# Access Compliance Report

## Public Rights-of-Way

### (Curb Ramps)

Intersection ID: 21503	Main Street: BLUEBERRY_LN	Cross Street: PROVIDENCE_RD	Location: SW
ADA ID: 59B627F708AF	Ramp Type: PerpDiag	Initial Pass/Fail: Fail	Overall Compliance: No
Severity Score: 8.75			
Codes/Mitigation Info/Possible Solution		Field Measurements/Component Compliance

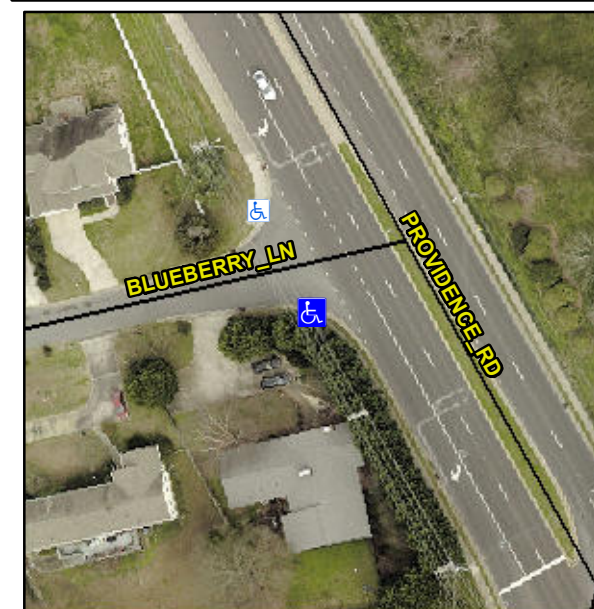
**Not Found, R304.5.1**

Compliance	Description	Data	Compliance	Description	Data
N/A	Ramp Length (in)	70.0	Yes	Ramp Slope (%)	6.6
No	Ramp Width (in)	36.0	Yes	Ramp XSlope (%)	1.4
N/A	Flare Type LT	N/A	N/A	Flare Type RT	N/A
N/A	Flare Slope LT (%)	N/A	N/A	Flare Slope RT (%)	N/A
N/A	Flare Traversable LT?	N/A	N/A	Flare Traversable RT?	N/A
N/A	Landing Length (in)	N/A	N/A	DWS Provided?	N/A
N/A	Landing Width (in)	N/A	N/A	DWS Contrast?	N/A
N/A	Landing Slope (%)	N/A	N/A	DWS Length (in)	N/A
N/A	Landing X Slope (%)	N/A	N/A	DWS Full Width?	N/A
N/A	Landing Curb? (Y/N)	N/A	N/A	DWS Offset (in)	N/A
N/A	Shared Landing?	N/A			
N/A	Gutter Ponding?	N/A	N/A	Gutter Slope (%)	N/A
N/A	Gutter Lip Ht (in)	N/A	N/A	Gutter X Slope (%)	N/A
N/A	Painted X Walk1?	No	N/A	Painted X Walk2?	No
	X Walk 1 Direction	To E		X Walk 2 Direction	To N
N/A	X Walk 1 Width (in)	N/A	N/A	X Walk 2 Width (in)	N/A
	X Walk 1 Slope (%)	1.4		X Walk 2 Slope (%)	1.0
	X Walk 1 X Slope (%)	0.4		X Walk 2 X Slope (%)	1.7

**Remove & Replace Curb Ramp With Two New Directional Ramps or Equivalent.**
